Re: Marist Catholic College North Shore
Application No.: SSD-10473

Response to Exhibition of Amended State Significant Development Application

2 CARLOW ST SECTION

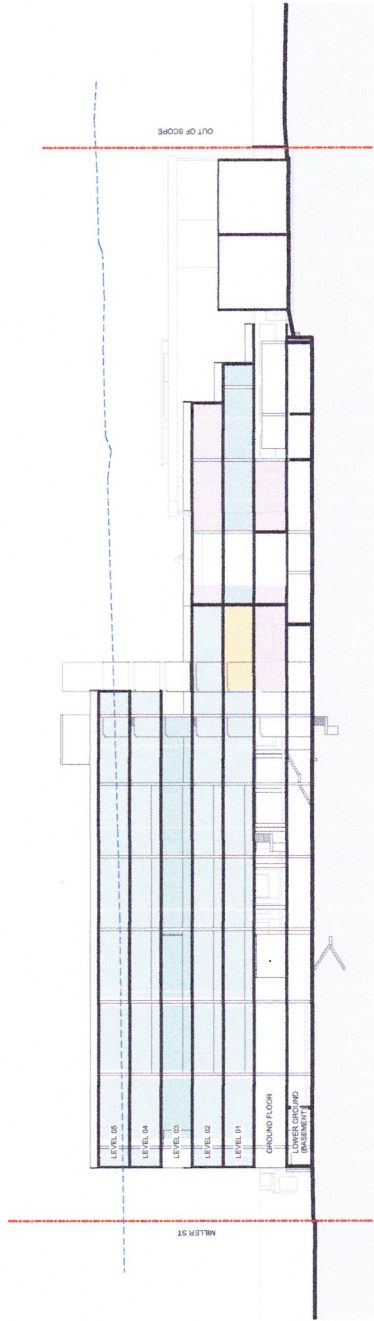
1. Our reading of the Carlow Street Building Sections contained in the original concept plan for the site, is that it was proposed that the building on the corner of Miller and Carlow Streets would be 5 levels above ground floor at the Miller Street corner and then reduce to 2 levels above ground floor where the building was (approximately) opposite the residential area of Carlow Street (west of Tucker Street). This reduction in height was also confirmed (in our reading of the concept plan) by the Ridge Street Building Section which showed that the western end of the Carlow Street would not be visible above the rooftop of the St Mary's Primary School located on Ridge Street.

(Refer attached Annexure A – Pages 16 and 17 of North Shore Education Precinct| School Masterplan Report)

The current plans, indicate the entire Carlow Street Building will now be 4 levels above ground with a rooftop recreation space, resulting in an overall increase in the building mass. As currently proposed, the building's frontage to Carlow Street at its western end will be ~20m (natural ground level). This is significantly higher than any other building in the residential area of Carlow Street and the maximum building height of 12 metres outlined in the North Sydney Local Environment Plan 2013 (Clause 4.3).

It is requested that the building mass be returned to the design outlined in the original concept plan which would provide more alignment with the surrounding residential properties.
